STAFF RECOMMENDATION 810 Powers Avenue December 19, 2018

Application: New Construction-Addition
District: Eastwood Neighborhood Conservation Zoning Overlay
Council District: 06
Map and Parcel Number: 08307004800
Applicant: David Morgan, architect
Project Lead: Jenny Warren, jenladenheim@hotmail.com

Description of Project: Application is for the construction of a rear addition.

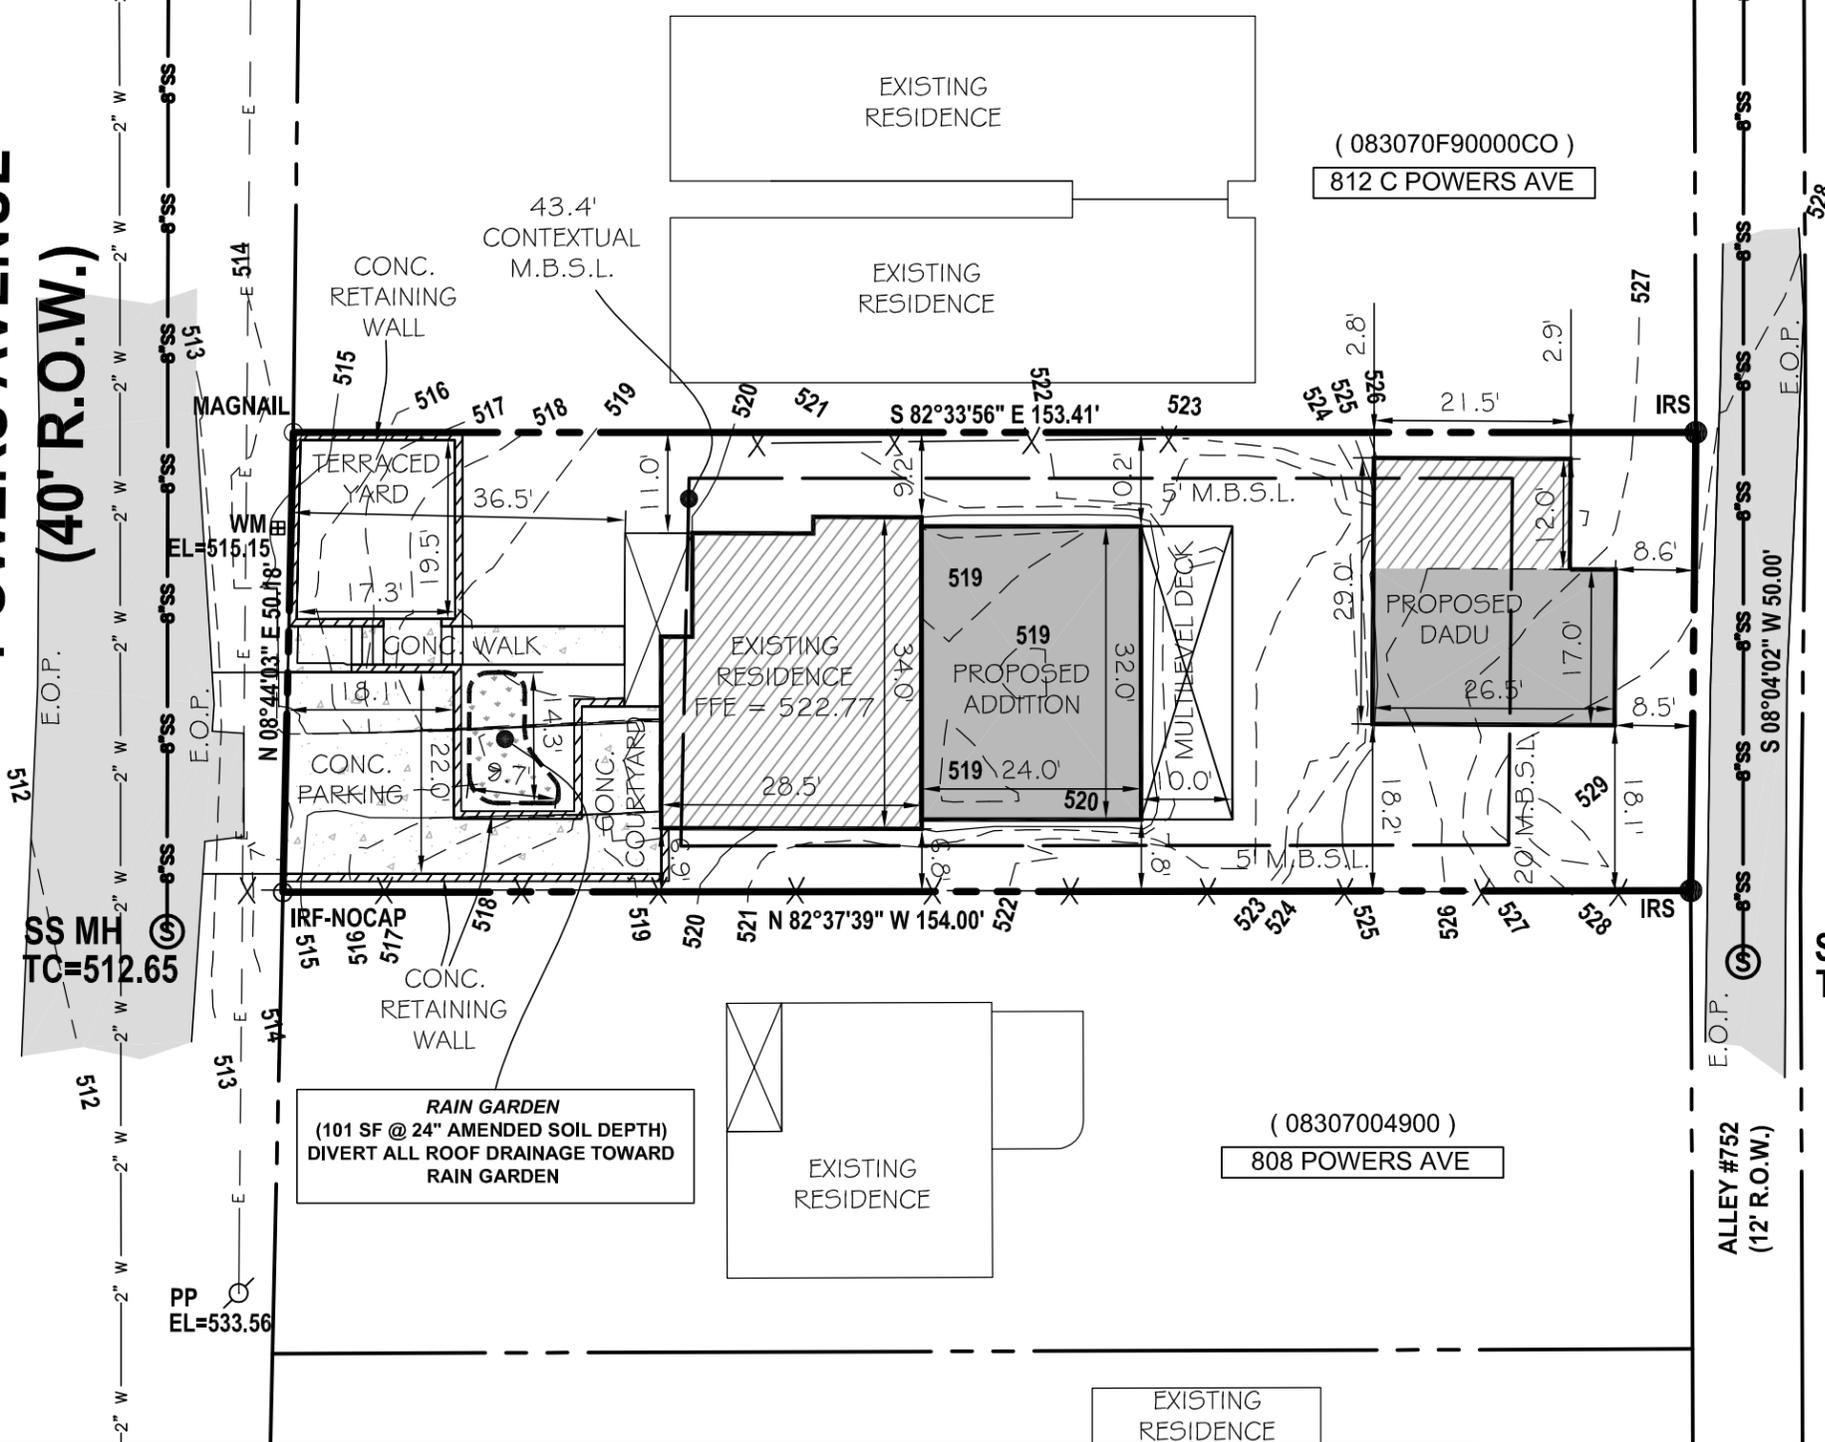
dormer above it will inset another one foot, six inches (1'6") from the first floor, making the face of the dormer flush with exterior wall of the historic second story on this side. Staff requests that the applicant inset this dormer an additional two feet (2'), so that it is inset two feet (2') from the historic wall plane.

Figure 5: Left side elevation. Dormer proposed to be flush with historic side gable, rather than inset.

1. The dormer on the left side shall be inset two feet (2') beyond the plane of the existing second story wall;
2. The addition shall tie into the historic roof at least six inches (6") below the existing ridgeline;
3. The lap siding shall have a five inch (5") exposure;
4. The front porch columns shall be painted wood and have simple bases and capitals;
5. Staff shall approve the final materials prior to purchase and installation, including roofing, trim, front and rear porch posts, rear porch floor and steps, rear porch railing, doors and windows; and,
6. The HVAC shall be located behind the house or on either side, beyond the mid-point of the house,

Historic Elevations

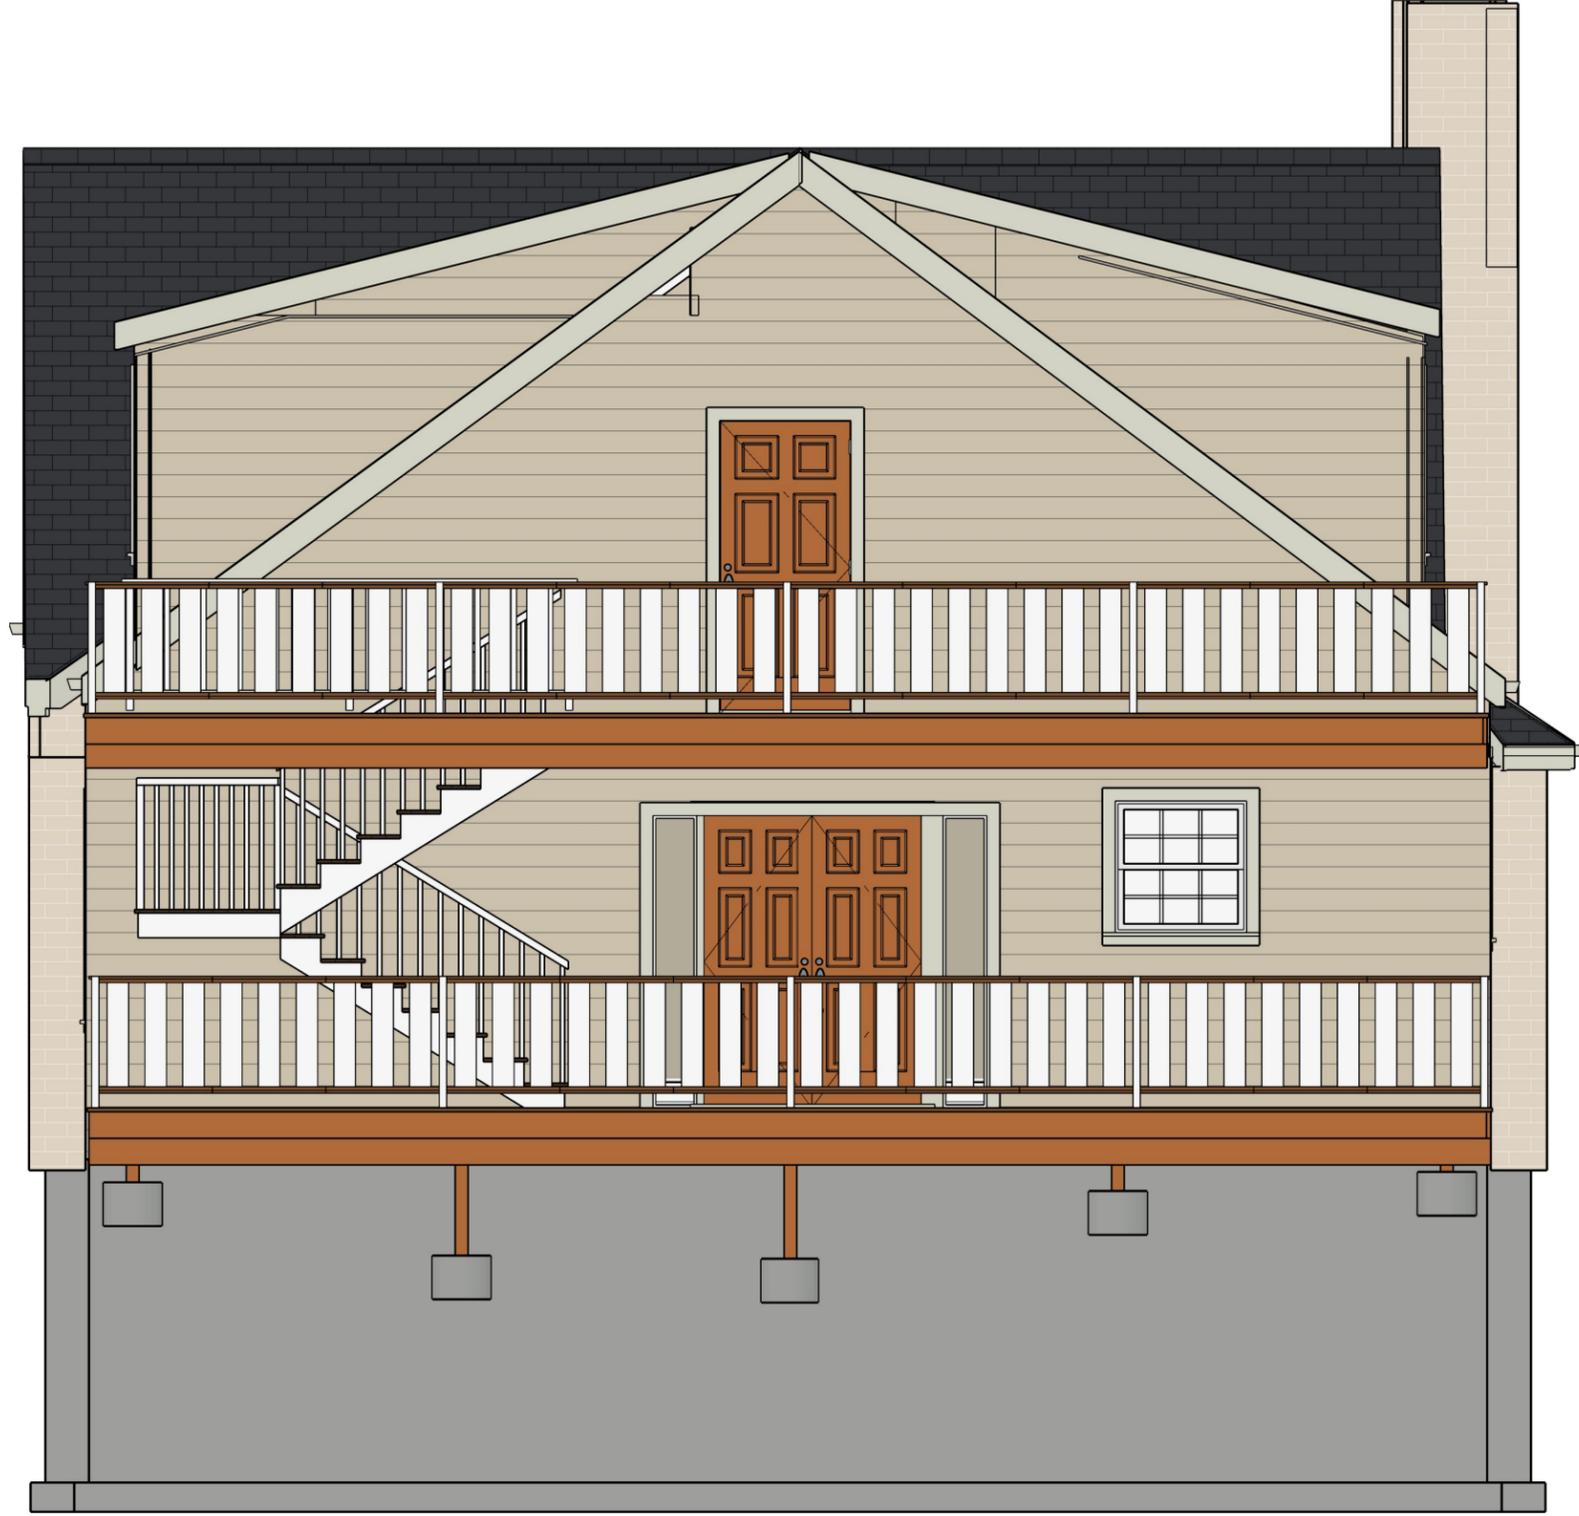
With the conditions that the dormer on the left side be inset an additional two feet (2'), and that the addition tie into the existing ridge at least six inches (6") below the existing ridge, staff finds that the project meets section II.B.1.a.and b for height and scale.

1. The dormer on the left side shall be inset two feet (2') beyond the plane of the existing second story wall;
2. The addition shall tie into the historic roof at least six inches (6") below the existing ridgeline;
3. The lap siding shall have a five inch (5") exposure;
4. The front porch columns shall be painted wood and have simple bases and capitals;
5. Staff shall approve the final materials prior to purchase and installation, including roofing, trim, front and rear porch posts, rear porch floor and steps, rear porch railing, doors and windows; and,
6. The HVAC shall be located behind the house or on either side, beyond the mid-point of the house,
